Office Action Summary

10/798,933

This is a first office action on the merits of application SN 10/798,933.

Anderson '847 Figure 1

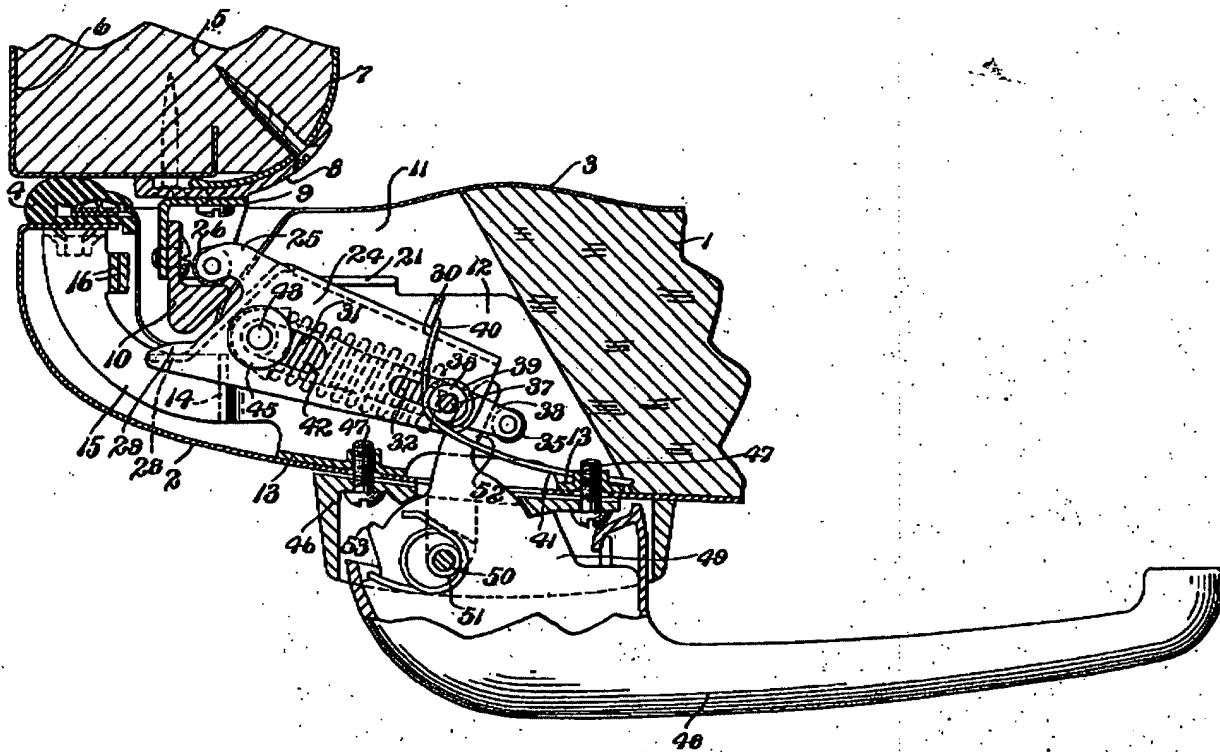
2. Claims 1-7, 12-15, 16, and 21-26 rejected under 35 U.S.C. 102(b) as being anticipated by US Patent 2,507,847 to Anderson. Anderson teaches a refrigerator that comprises a housing with a door pivotally coupled to the housing. A striker (10) is connected to the housing. A latching arrangement is carried by the door and includes a handle (48) connected to the door for movement between a first position and a second position. The handle (48) defines an arcuate cam surface by a finger (52). A pawl (24, 25, 26, 33, 35) is connected to the door for movement between a latched position that is engaged with the striker for securing the door in a closed position and an unlatched position allowing the door to be pivoted from the closed position. The pawl including a cam follower (35) that cooperate with the at least one cam surface such that movement of the handle from the first position to the second position moves the pawl from the latched position (Fig 1) to the unlatched position (Fig 2). The handle (48) is pivotally connected to the door for rotation about a first pivot axis (50). The pawl is pivotally connected to the door for rotation about a second pivot axis (37). The first and second

pivot axis are spaced apart from one another, parallel, and vertical. The handle carries a biasing element (51) for biasing the handle to the first position. The latching arrangement is located at an edge of the door. A side of the door defines a recess (11) and the finger (52) of the handle (48) is disposed in the recess (11). Regarding claim 14, the refrigerator being for a motor vehicle gives the limitation that the refrigerator is capable of being used in a motor vehicle. There exist motor vehicles more commonly known as RV's that can produce the standard voltage needed to operate an refrigerator and is therefore capable of operating the refrigerator of Anderson.

Geddes '467 Figure 3

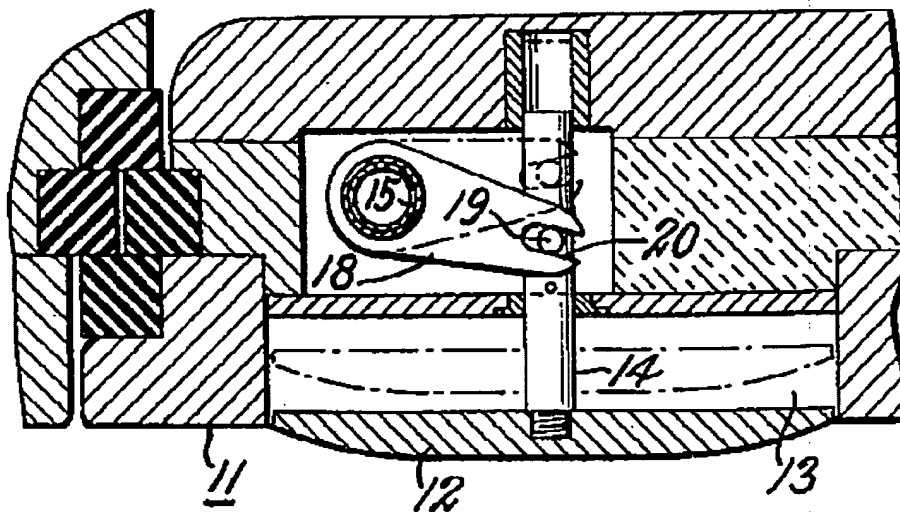
including a slot defining the cam surface, the slot being an arcuate slot, and the slot defined by a pair of fingers. Geddes teaches a refrigerator latch with a lever arm (18) with a slot (19) defined by a pair of fingers on both sides of the slot (19) that have a cam surface that engage a cam follower (20). At the time of the invention it would have been obvious for a person of ordinary skill to modify the handle of Anderson by adding a second finger in the same arcuate shape to create a slot as taught by Geddes so that the cam follower has two cam surface one for each direction of movement.

Negrao '174 Figure 1

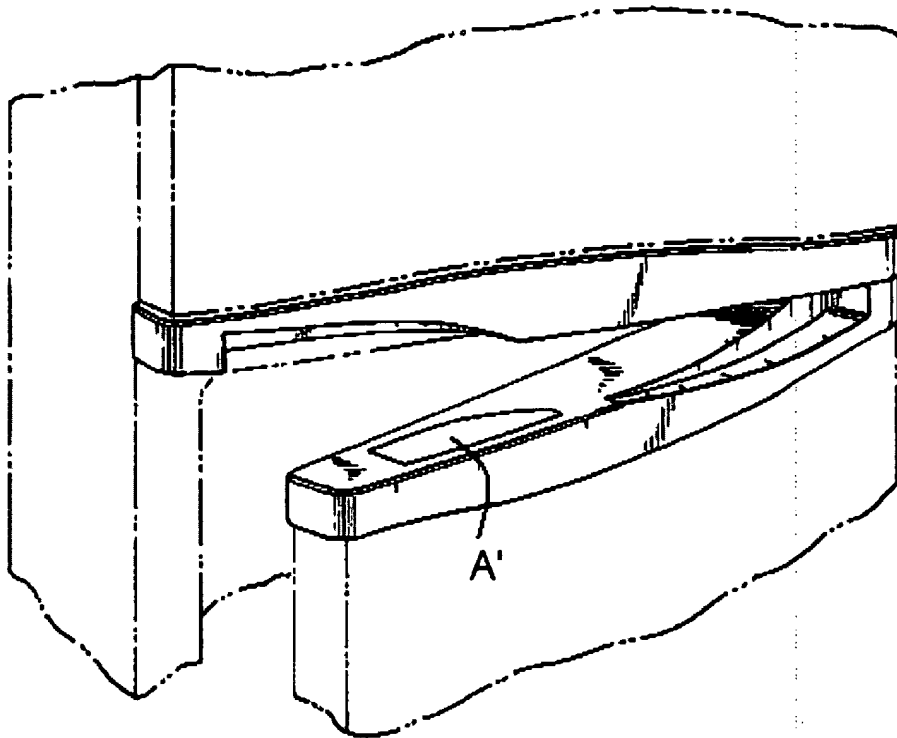
7. Claim 27 and 28 are rejected under 35 U.S.C. 103(a) as being unpatentable over US Patent 2,507,847 to Anderson in view of US Design Patent 430,174 to Negrao. Anderson discloses every element as claimed and discussed above except the side of door being the topside of the door and the handle is at least partly concealed by a perimeter of the door. Negrao teaches a refrigerator with a door that has a handle (A')

located in the topside of the door and is concealed by a perimeter of the door. At the time of the invention it would have been obvious for a person of ordinary skill to modify the refrigerator of Anderson by having the handle located at the top side of the door with the perimeter concealing a portion of it as taught by Negrao to make the refrigerator more aesthetically pleasing.
